# File PL 22-3740 Series C Code Amendments

Planning Commission

December 13, 2022

# Series C – Section 8

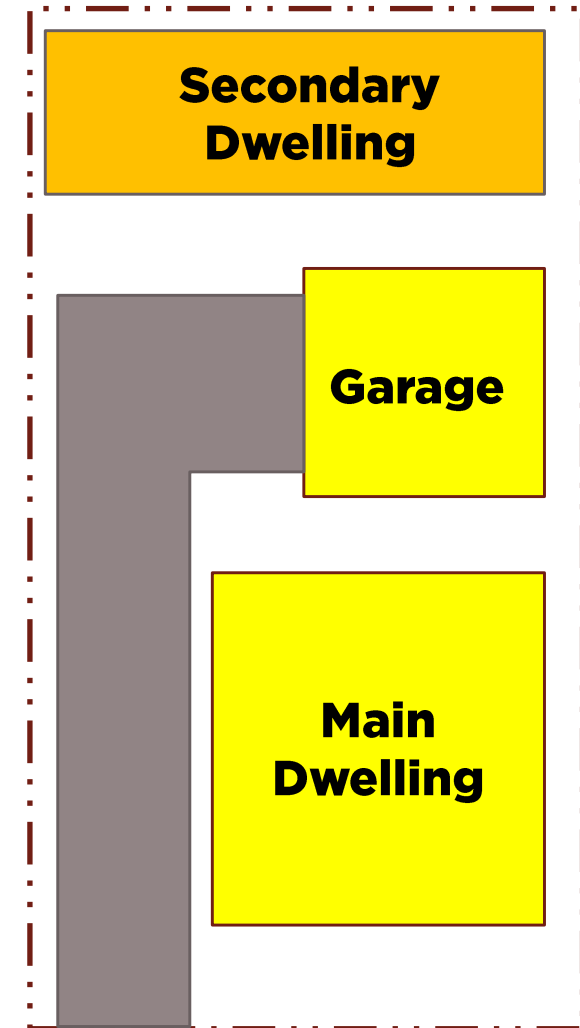
- Problem: Detached accessory structures have size limits.
- Solution: Add that required garages for the main dwelling cannot be attached to detached structures used as habitable space.
